CITY OF FORT COLLINS

ADDENDUM No. 1
BID #5764
VEHICLE: CUT-A-WAY VAN

Description of Bid #5764 Vehicle: Cut-A-Way Van

Floor Plan

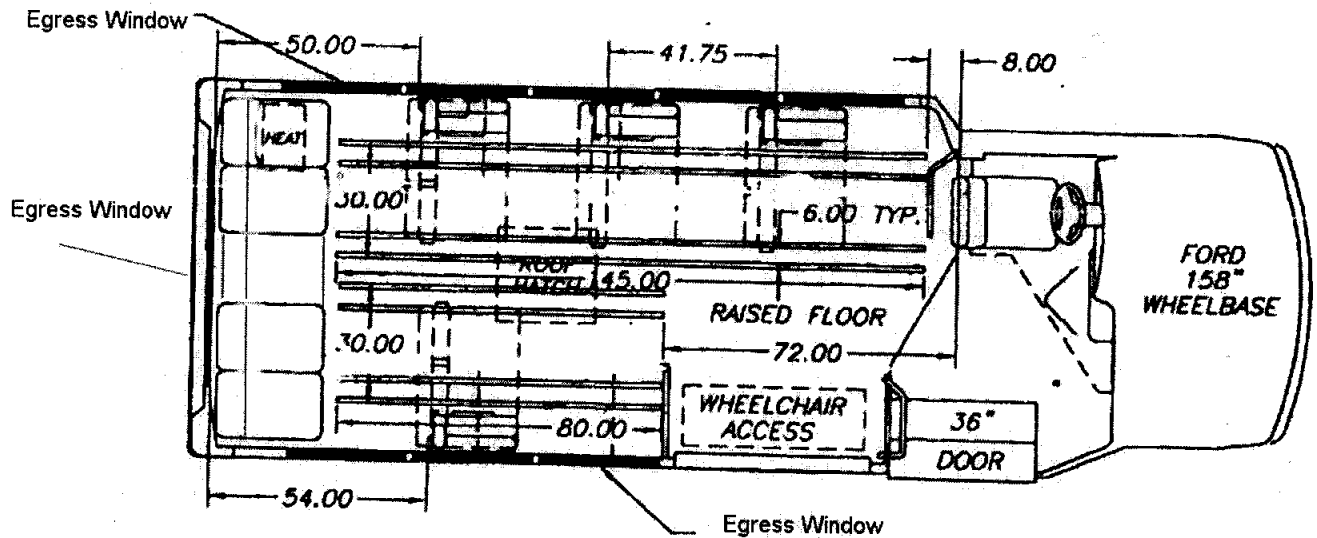
No floor plan was included in the original bid. Here is a general layout.

Bidders should use this as a guide in preparing proposed seating arrangements.
